ECE/TRANS/WP.29/2009/87  
29 July 2009

**World Forum for Harmonization of Vehicle Regulations**

Proposal for Supplement 34 to the 03 series of amendments to Regulation No. 37  
(Filament lamps of power-driven vehicles and their trailers)

Submitted by the Working Party on Lighting and Light-Signalling \*/

### Category H16

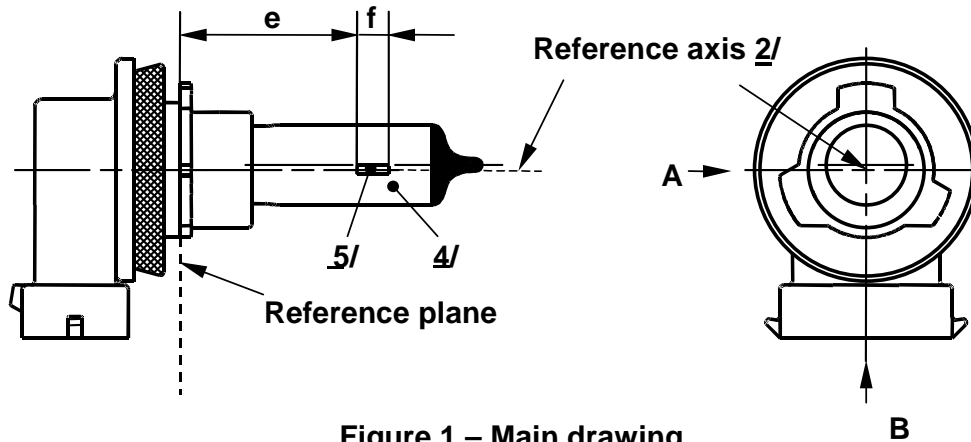
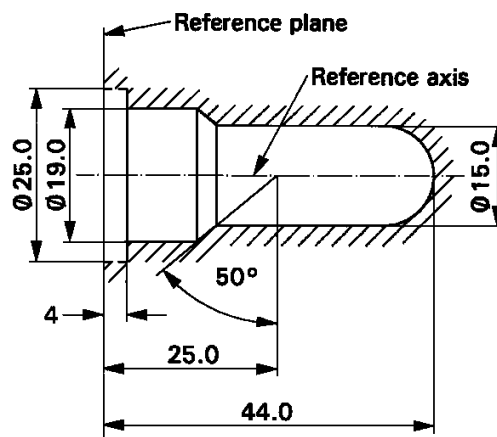
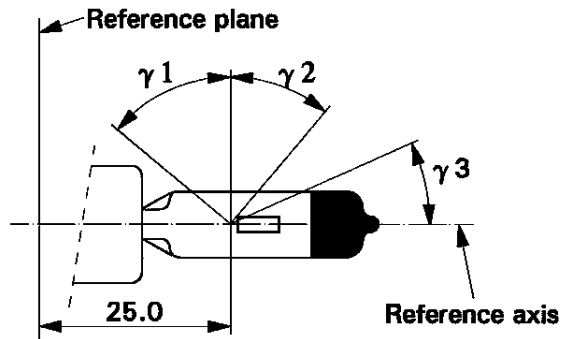
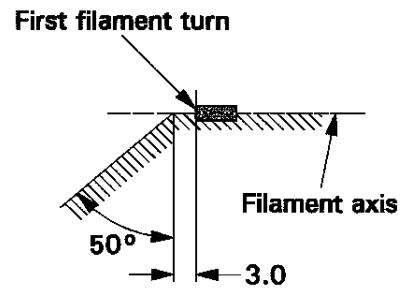
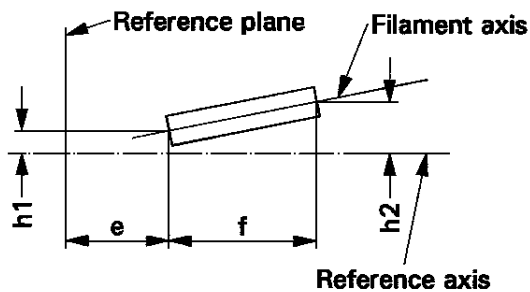
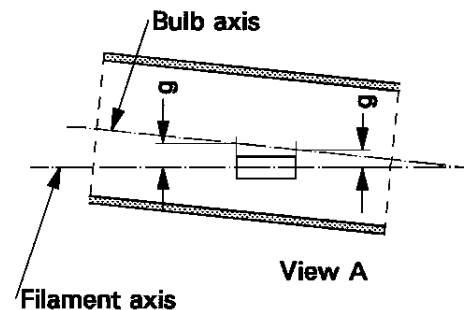
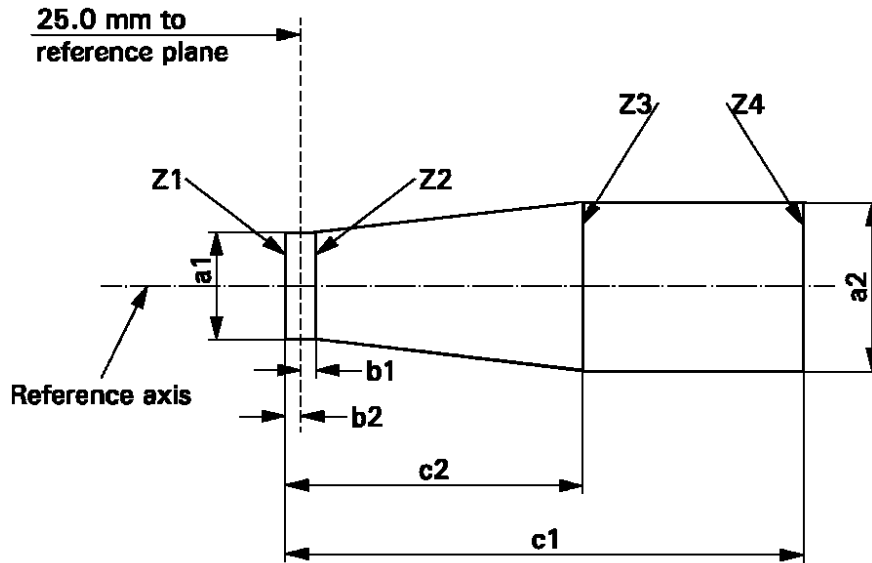
Insert new sheets H16/1 to 4, between sheet H15/5 and H6W/1, to read (see next pages):

- 6/ Glass bulb shall be optically distortion free within the angles  $\gamma_1$  and  $\gamma_2$ . This requirement applies to the whole bulb circumference within the angles  $\gamma_1$  and  $\gamma_2$ .

- 7/ The obscuration shall extend at least to angle  $\gamma_3$  and shall extend at least to the cylindrical part of the bulb on the whole bulb top circumference.

- 8/ The internal design of the lamp shall be such that stray light images and reflections are only located above the filament itself seen from the horizontal direction. (View A as indicated in Figure 1 on sheet H16/1). No metal parts other than filament turns shall be located in the shaded area as seen in Figure 4.

- 9/ The offset of the filament with respect to the reference axis is measured only in viewing directions A and B as shown in Figure 1 in sheet H16/1. The points to be measured are those where the projection of the outside of the end turns nearest to or furthest from the reference plane crosses the filament axis.

- 10/ Offset of filament in relation to bulb axis measured in two planes parallel to the reference plane where the projection of the outside of the end turns nearest to or furthest from the reference plane crosses the filament axis.

Dimensions in mm	Filaments lamps of normal production		Standard filament lamp	
	12 V		12 V	
e	<u>11/</u>	25.0	<u>12/</u>	25.0 ± 0.1
f	<u>11/</u>	3.2	<u>12/</u>	3.2 ± 0.1
g		0.5 min.		u.c.
h1		0	<u>12/</u>	0 ± 0.1
h2		0	<u>12/</u>	0 ± 0.15
γ1		50° min.		50° min.
γ2		40° min.		40° min.
γ3		30° min.		30° min.
Cap:	H16: PGJ19-3	in accordance with IEC Publication 60061 (sheet 7004-110-2)		
ELECTRICAL AND PHOTOMETRIC CHARACTERISTICS				
Rated values	Volts	12		12
	Watts	19		19
Test voltage	Volts	13.2		13.2
Objective values	Watts	22 max.		22 max.
	Luminous flux	500 +10% / -15 %		
Reference luminous flux: 500 lm at approximately 13.2 V				
Reference luminous flux: 550 lm at approximately 13.5 V

11/ The ends of the filament are defined as the points where, when the viewing direction is direction A as shown in Figure 1 on sheet H16/1, the projection of the outside of the end turns crosses the filament axis.

12/ To be checked by means of a "Box System"; sheet H16/4.

Screen projection requirements

This test is used to determine, by checking whether the filament is correctly positioned relative to the reference axis and reference plane, whether a filament complies with the requirements.

The filament position is checked solely in directions A and B as shown on sheet H16/1, Figure 1.

The filament shall lie entirely within the limits shown.

The ends of the filament as defined on sheet H16/3, note 11/, shall lie between lines Z1 and Z2 and between Z3 and Z4."

" CATEGORY HS5A Sheet HS5A/1

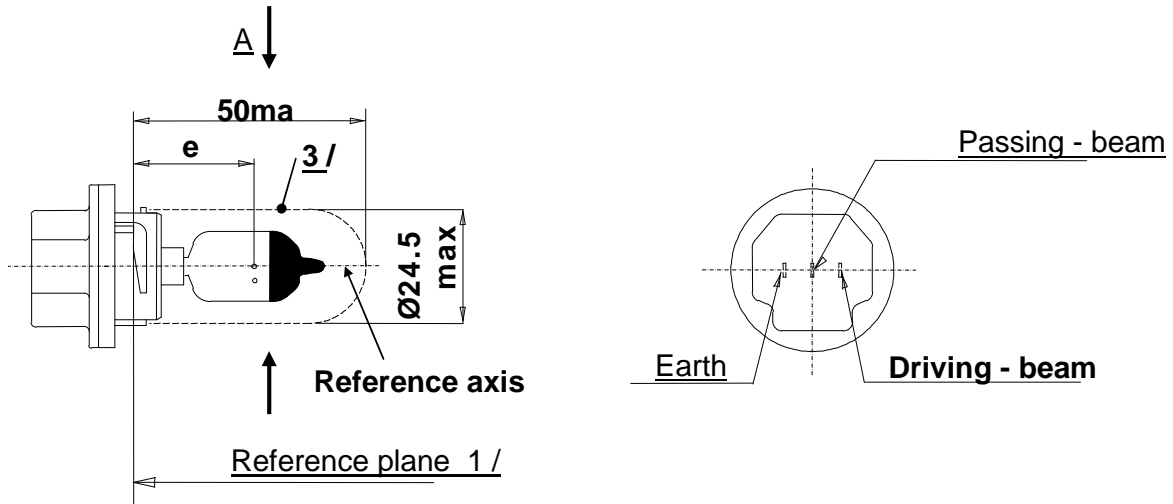
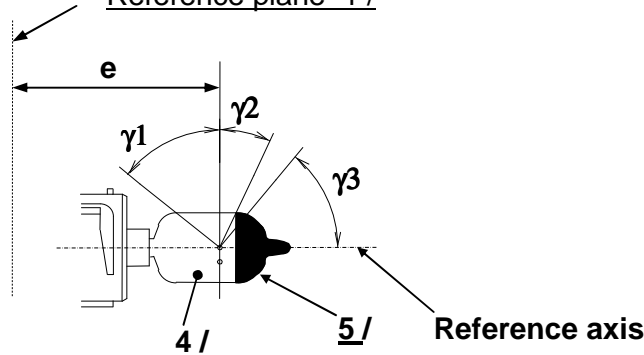
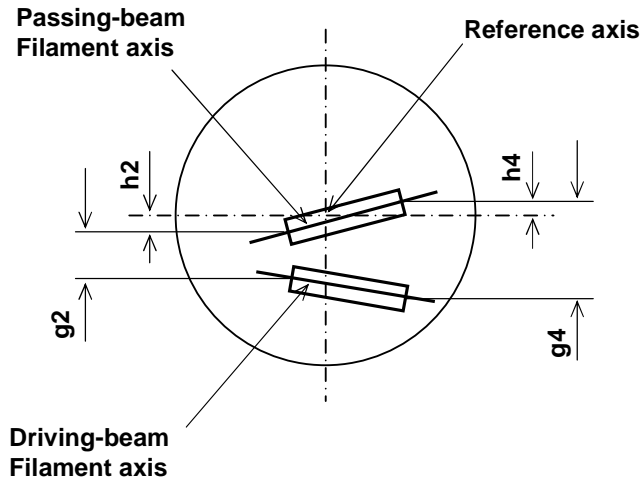
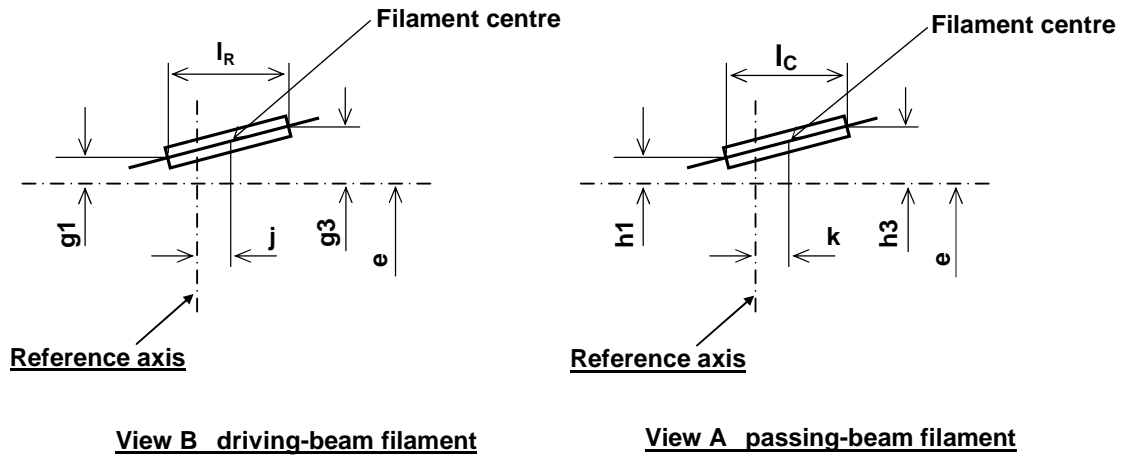
Insert new sheets HS5A/1 to 3, between sheet HS5/4 and sheet HS6/1, to read:

- 1/ The reference plane is defined by three ramps inside surface.
- 2/ The reference axis is perpendicular to the reference plane and passing through the centre of the 23 mm cap diameter.
- 3/ Glass bulb and supports shall not exceed the envelope as indicated in figure 1. The envelope is concentric to the reference axis.
- 4/ Glass bulb shall be optically distortion free within the angles  $\gamma_1$  and  $\gamma_2$ . This requirement applies to the whole bulb circumference within the angles  $\gamma_1$  and  $\gamma_2$ .
- 5/ The obscuration shall extend at least to angle  $\gamma_3$  and shall extend at least to the cylindrical part of the bulb on the whole top circumference.

Dimensions in mm		Filament lamps of normal production		Standard filament lamp		
		12V		12V		
e	26	—		—		
l <sub>c</sub>	<u>6/</u> 4.6	±0.5		± 0.3		
k	0	±0.4		± 0.2		
h1, h3	0	±0.3		± 0.15		
h2, h4	0	±0.4		± 0.2		
l <sub>R</sub>	<u>6/</u> 4.6	±0.5		± 0.3		
j	0	±0.6		± 0.3		
g1, g3	0	±0.6		± 0.3		
g2, g4	2.5	±0.4		± 0.2		
γ <sub>1</sub>	50° min.	-		-		
γ <sub>2</sub>	23° min.	-		-		
γ <sub>3</sub>	50° min.	-		-		
Cap PX23t in accordance with IEC Publication 60061 (sheet 7004-138A-1)						
ELECTRICAL AND PHOTOMETRIC CHARACTERISTICS						
Rated values	Voltage	V	12 <u>7/</u>		12 <u>7/</u>	
	Wattage	W	45	40	45	40
Test voltage		V	13.2		13.2	
Objective Values	Wattage	W	50 max.	45 max.	50 max.	45 max.
	Luminous flux	lm	750	640		
		±%	15	15		
Reference luminous at approximately		12V			550 lm	470 lm
		13.2V			750 lm	640 lm

6/ The positions of the first and the last turn of the filament are defined by the intersections of the outside of the first and the outside of the last light-emitting turn, respectively, with the plane parallel to and 26 mm distant from the reference plane.

7/ The values indicated in the left-hand columns relate to the driving-beam filament and those indicated in the right-hand columns to the passing-beam filament. "

**CATEGORY PSX26W**

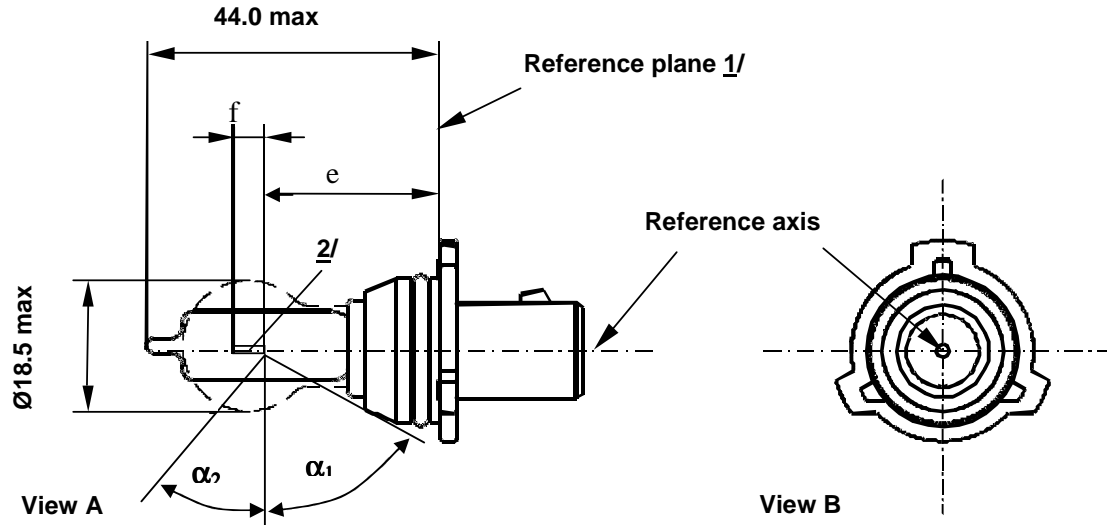
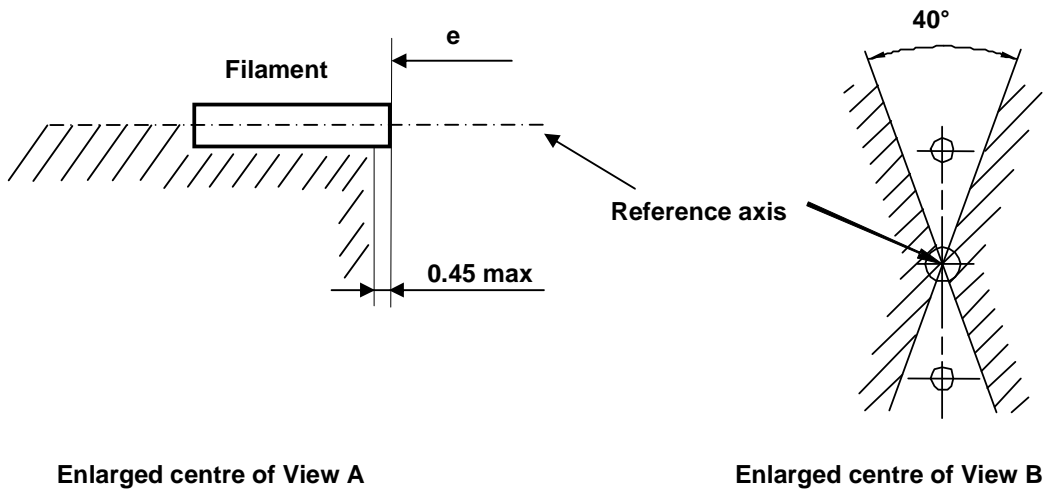
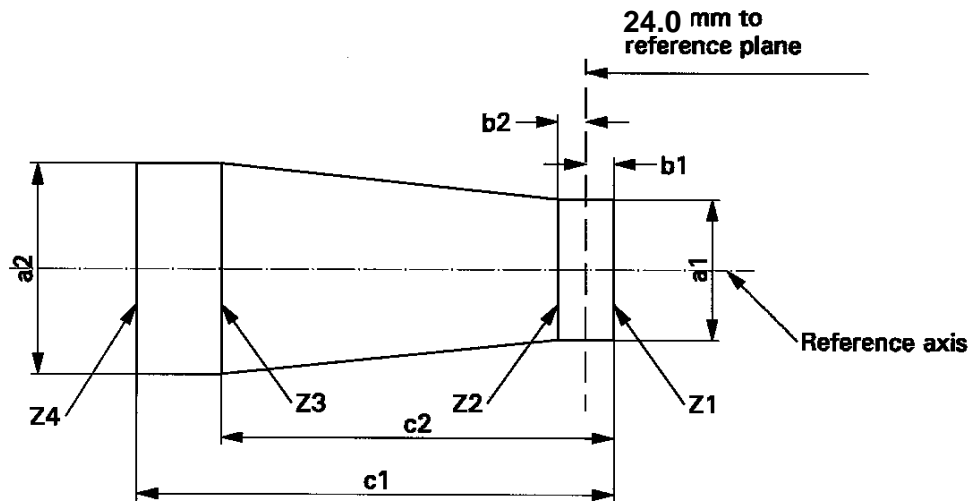
Insert new sheets PSX26W/1 to 3, between sheet PR27/7W/1 and sheet PY21W/1, to read:

- 1/ The reference plane is defined by the meeting points of the cap-holder fit.
- 2/ No actual filament diameter restrictions apply but the objective is  $d_{max} = 1.1$  mm.
- 3/ No opaque parts other than filament turns shall be located in the shaded area indicated in Figure 2. This applies to the rotational body within the angles  $\alpha_1 + \alpha_2$ .

Dimensions in mm		Filament lamps of normal production		Standard filament lamp
e	<u>5/</u>	24.0	<u>4/</u>	24.0 ± 0.25
f	<u>5/</u>	4.2	<u>4/</u>	4.2 ± 0.25
α1	<u>6/</u>	35.0° min.		35.0° min.
α2	<u>6/</u>	58.0° min.		58.0° min.
Cap PG18.5d-3		in accordance with IEC Publication 60061 (sheet 7004-147-1)		
ELECTRICAL AND PHOTOMETRIC CHARACTERISTICS				
Rated values	Voltage	V	12	12
	Wattage	W	26	26
Test voltage		V	13.5	13.5
Objective values	Wattage	W	26 max.	26 max.
	Luminous flux	lm	500	
		±	+10% / -10%	
Reference luminous flux at approximately 13.2V				465 lm
Reference luminous flux at approximately 13.5V				500 lm

4/ To be checked by means of a "Box-System"; sheet PSX26W/3.

5/ The ends of the filament are defined as the points where, when the viewing direction is perpendicular to the plane through the filament lead-in wires, the projection of the outside of the end turns crosses the filament axis.

6/ No part of the cap beyond the reference plane shall interfere with angle α2 as shown in Figure 1 on sheet PSX26W/1. The bulb shall be optically distortion free within the angles α1+ α2. These requirements apply to the whole bulb circumference.

Screen projection requirements

This test is used to determine, by checking whether the filament is correctly positioned relative to the reference axis and reference plane, whether a filament lamp complies with the requirements.

a1	a2	b1,b2	c1	c2
Filament lamps of normal production	1.7	1.7	0.30	5.0	4.0
Standard filament lamps	1.5	1.5	0.25	4.7	4.0

The filament position is checked in two mutually perpendicular planes, one of them being the plane through the lead-in wires.

The ends of the filament as defined on sheet PSX26W/2, note 4/, shall lie between Z1 and Z2 and between the lines Z3 and Z4.

The filament shall lie entirely within the limits shown.
